Product Declaration

Applicant: HYUNDAI MOBIS CO.,LTD.
Product: Car Audio System
FCC ID: TQ8-ATC31EYAN
IC No.: 5074A-ATC31EYKN
Basic Model name: SVM [FCC(ATC31EYAN), IC(ATC31EYKN)]
Additional Model name: RVM[FCC(ATC30EYAN), IC(ATC30EYKN)]

SVM(Surround View Monitoring System)	RVM(Rear View Monitoring System)

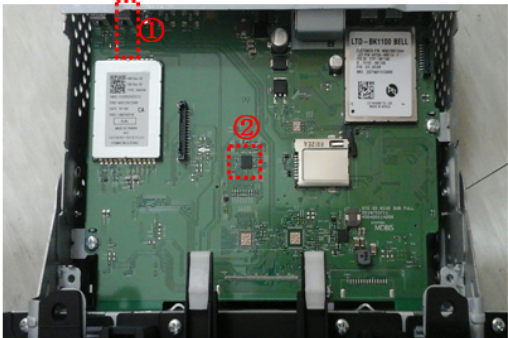
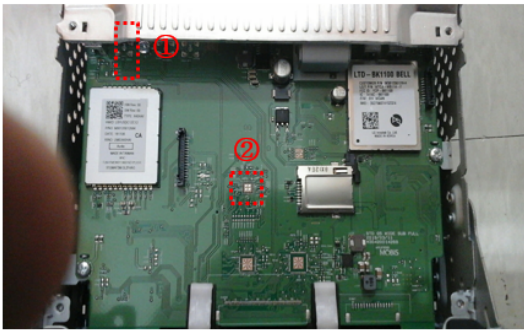
1. Image input connector is inserted 2. Insert LVDS processing IC	1. Image input connector is deleted 2. Delete LVDS processing IC

* The different parts that including SUB PCB are not affected to RF function.
